**STAFF REPORT
WEST ALLIS PLAN COMMISSION
Wednesday, October 23rd, 2024
Common Council Chambers
6:00 PM**

4. Site, Landscaping, and Architectural Design Review for the Barrel House, a proposed general retail use at 1350 S 108th St. (Tax Key Parcel: 444-0484-000)

2 NEW VESTIBULE PLAN
SCALE: 3/8" = 1'-0"

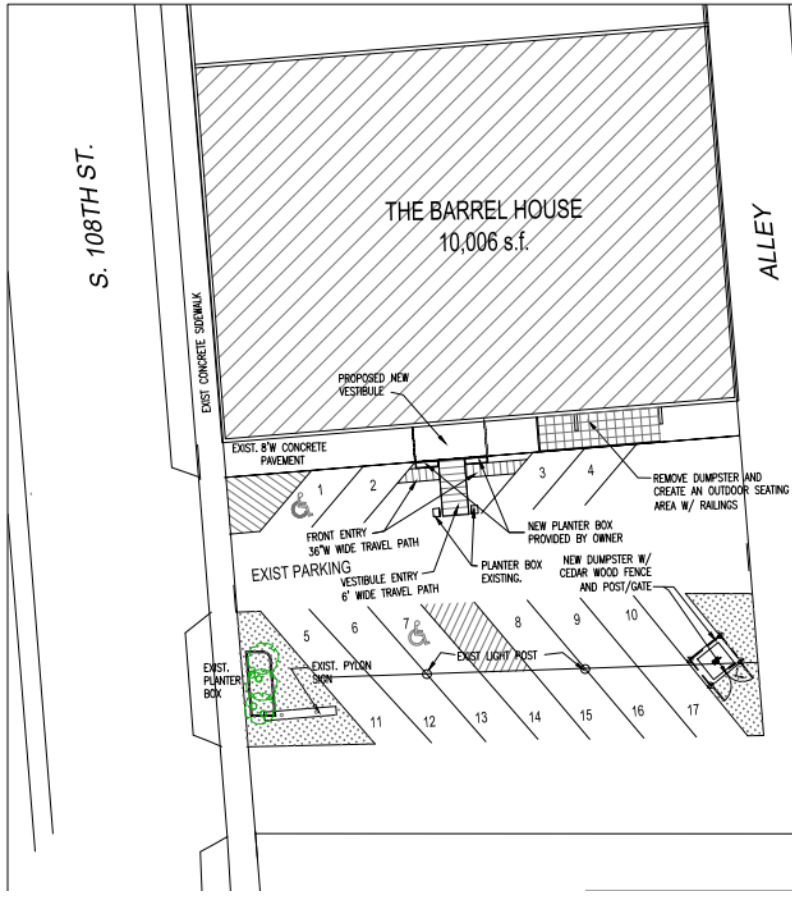
The greatest number of changes are proposed along the southern, parking lot-adjacent wall of the building. A cashier area will be located along this wall as well as a new cigar display area and humidor. A notable addition in this area includes plans for a new entrance vestibule. This 90 sq. ft. entrance feature will be updated with a new concrete stoop, and cement wall panel additions with concrete bond beams and rebar. While serving as the main entrance to the building, this area will also be used

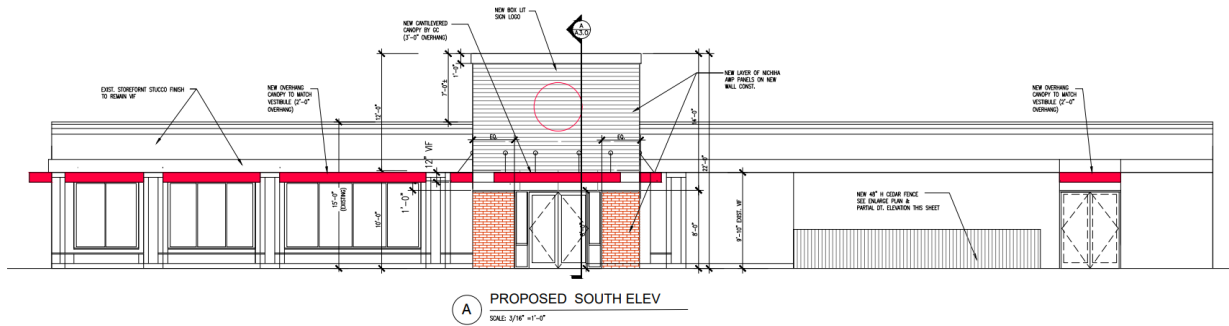
Refuse Container Location and Screening: A refuse enclosure currently exists at the entrance of the building where the proposed patio is planned to be located. A new dumpster with a cedar food fence and post gate will be relocated to the parking lot, adjacent to the alleyway and next to parking stalls 10 and 17.

Proposed Southern Elevation

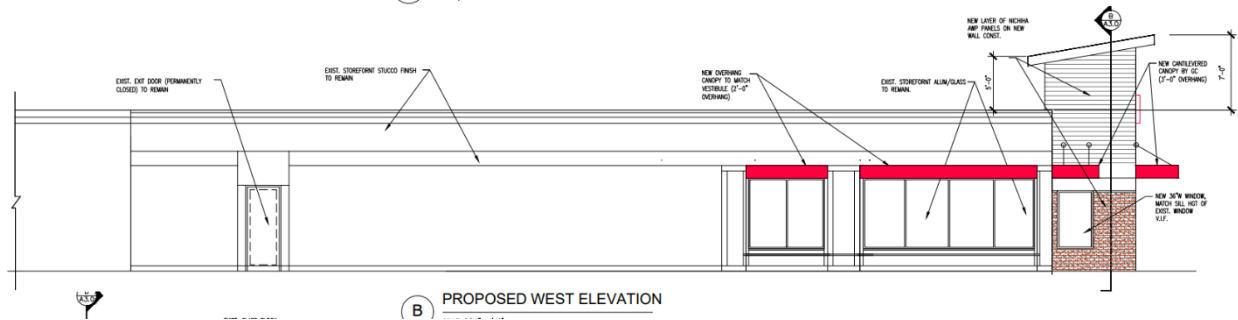
The existing stucco storefront finish of this elevation will remain, though some areas require maintenance. The applicant proposes new 2 ft. overhang canopies that will match the vestibule entrance. The entryway to the building will be updated with a new 3 ft. cantilevered canopy feature as well as new layers of Nichiha panel siding above the entryway. An additional canopy overhand above the side entrance leading to the patio is also accounted for in this architectural plan.

1. The submission of a Site, Landscaping, and Architectural Plan submitted to the Planning Office to show the following: (a) an indication of additional landscaping measures along the western edge of the property to extend beneath the existing pylon signage, species list included; (b) the indication of plant species to be installed within the hanging planter boxes along the new patio fencing; (c) the use of existing planters and planter boxes along the storefront to create an attractive storefront feature, with proposed plant species indicated (d) an updated architectural plan to indicate sections of the existing stucco façade in need of repair as well as indications of the scope of proposed repairs. Contact Emily Wagner, Planner, at 414-302-8465.

Proposed Western Elevation

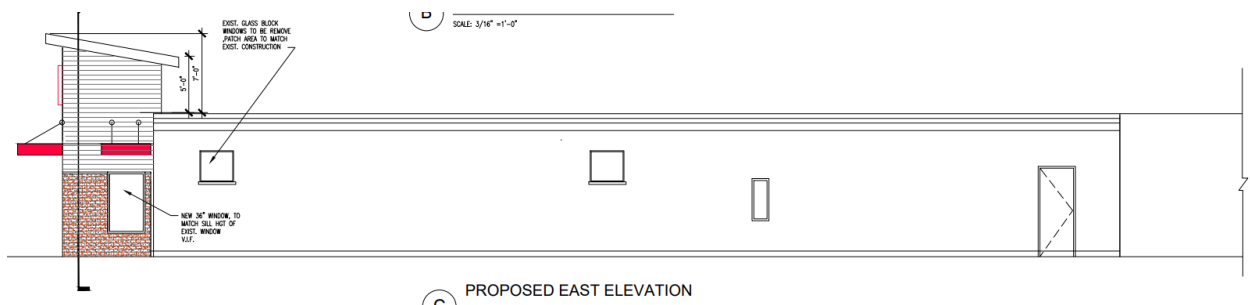
The western elevation indicates an existing exit door that will remain permanently closed as well as three additional 2 ft. overhang canopies on this side of the building. The storefront's existing window features will remain, with an additional window constructed along with the new vestibule entrance, which will match existing window features.
